GT Refresh

Overview of Product Changes

GMI Sales Awareness 8th October 2020

Corrective Actions – Flexible probe fails

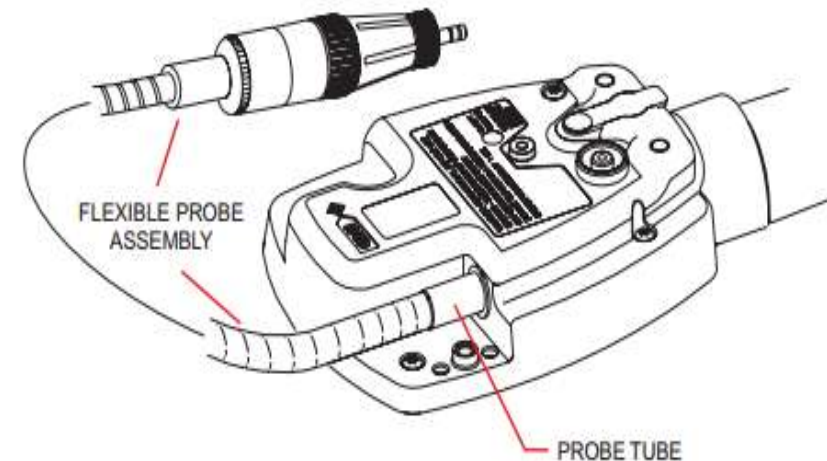
Loose probes, broken probe wires.

Probe held by a grub screw. Grub screw is not sufficient to hold the probe with repeated movement. Causes the probe to come loose and can cause the internal wires to break.

As part of maintenance regime probe glued in position on existing instruments

Corrective action: CN6363/6381

Probe glued in position on new builds.

A new spare rear assembly made with probe glued in position.

Corrective Actions - PSU

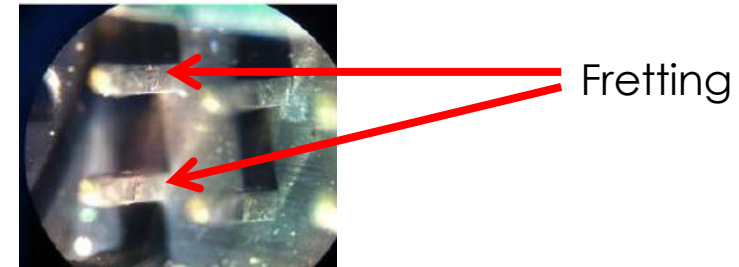
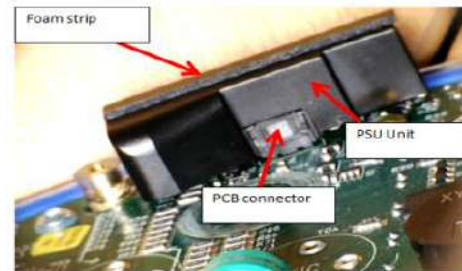
Various power failures would appear or disappear depending how tightly the housings were pressed or screwed together.

Signs of fretting between mating connectors of PSU.

Pump causing movements/vibrations resulting in fretting on tin plated contacts

PSU contact cleaning process implemented

Corrective action: CN6366

Gold connectors less prone to fretting. PSU connectors updated to gold plated parts. Implemented foam strip to immobilise the PSU.

Corrective Actions – Pump fails

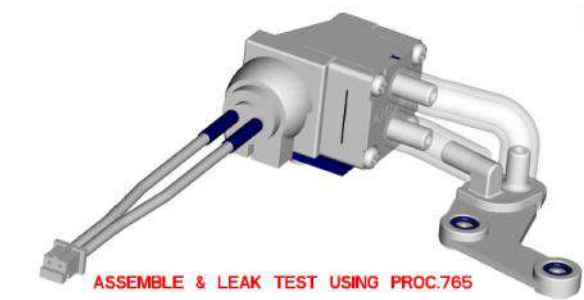
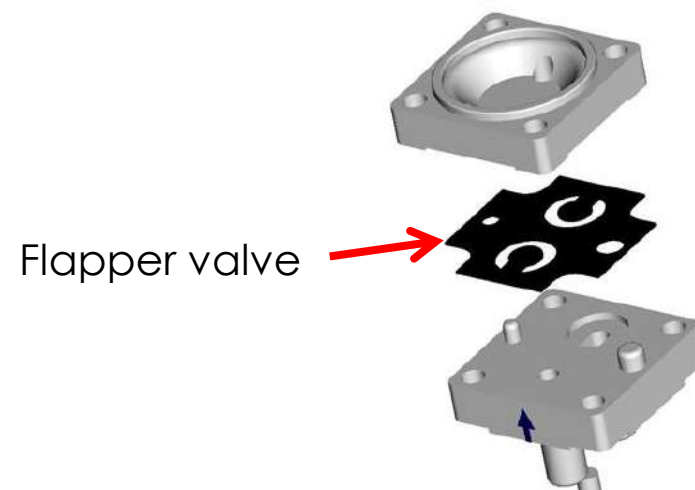
Variation in pump performance.

Rubber pump flapper valve is chlorinated. The chlorination is intended to make the rubber more robust. However, the chlorination process is not easily controlled, results in variation in the rubber flexibility affecting the pump performance.

- Pump flapper valve changed to unchlorinated material. Long term testing showed no deterioration in pump performance.
- Assembly methods reviewed.
- Production visual management tools implemented to monitor pump yield.
